**TOWN OF NEWBURGH  
PLANNING BOARD  
TECHNICAL REVIEW COMMENTS**

**PROJECT: CRONK ESTATES III**  
**PROJECT NO.: 2015-14**  
**PROJECT LOCATION: SECTION 1, BLOCK 2, LOT 17.24**  
**PROJECT REPRESENTATIVE: TALCOTT ENGINEERING**  
**REVIEW DATE: 5 AUGUST 2015**  
**MEETING DATE: 6 AUGUST 2015**

Re: Project Narrative  
P.B. Project No. 2015-14  
Cronk Estates III  
SBL: 1-2-17.24  
Job No. 14199-GGD

### PROJECT NARRATIVE

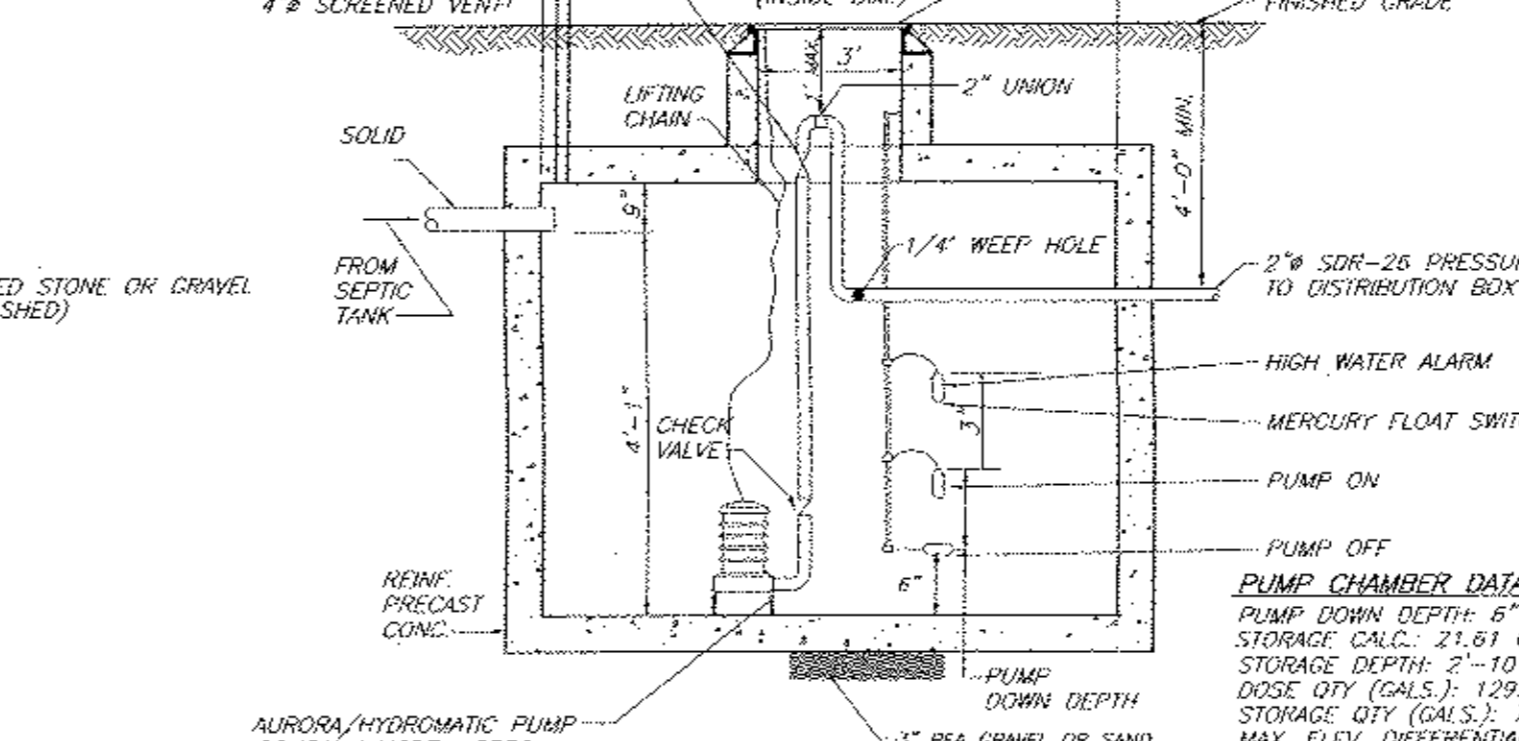
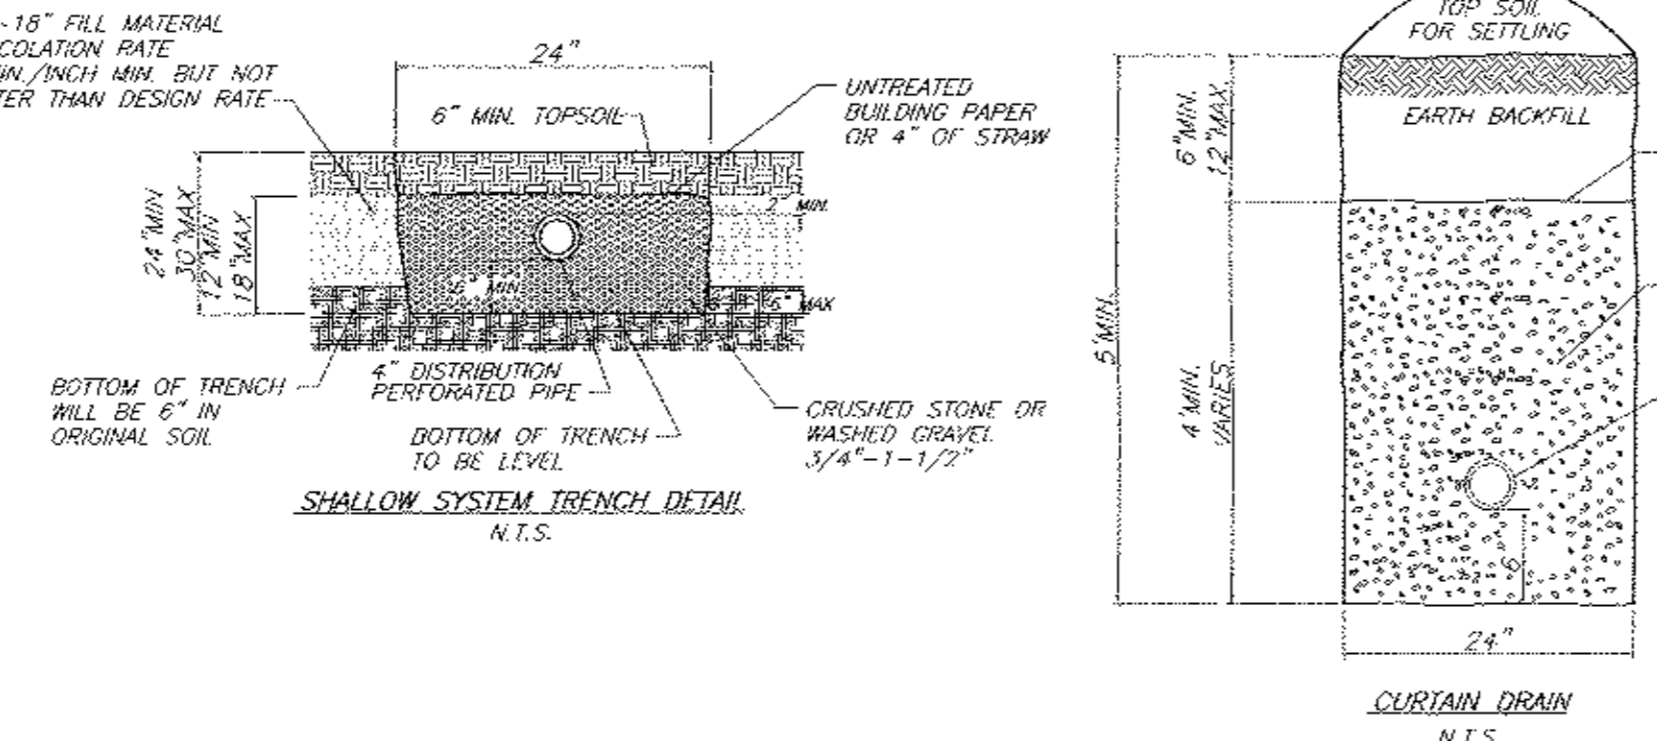
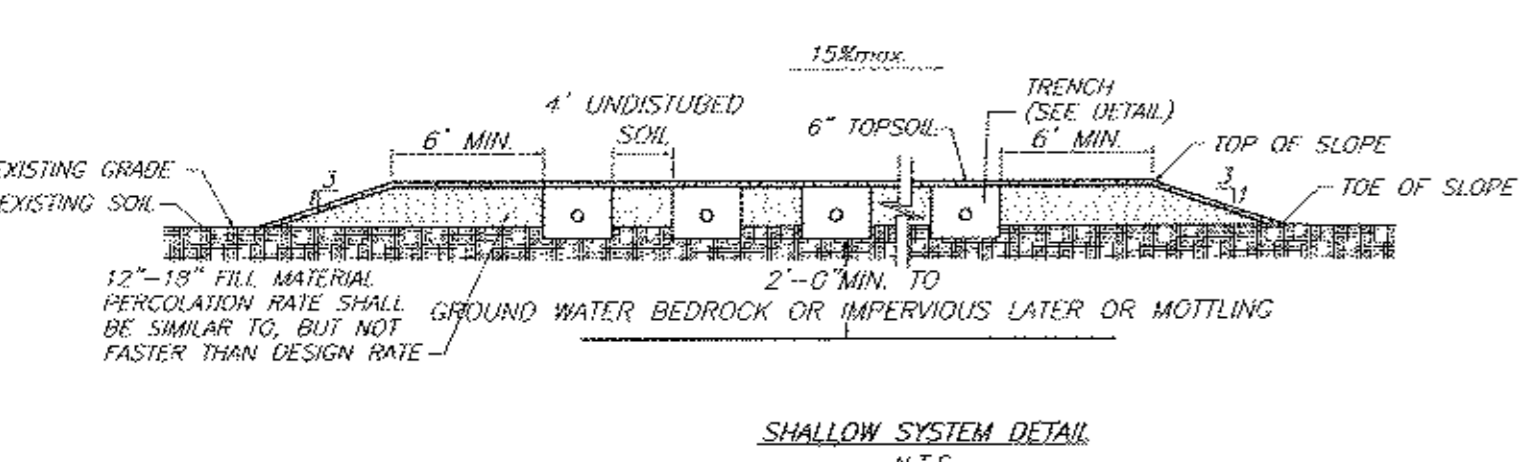
- 1) The date of the previous subdivision is June 1<sup>st</sup> 2012
- 2) Separation distance between the proposed lot 11 SDS and the existing lot #11 well in now 200' min.
- 3) Adjoining lots SDS and wells have been added
- 4) Culvert size on lot #11 is labeled as 15"
- 5) Project will be listed under previous SPDES.
- 6) Existing driveway on cul de sac are now shown.
- 7) Town note requiring asbuit have been added to plans.
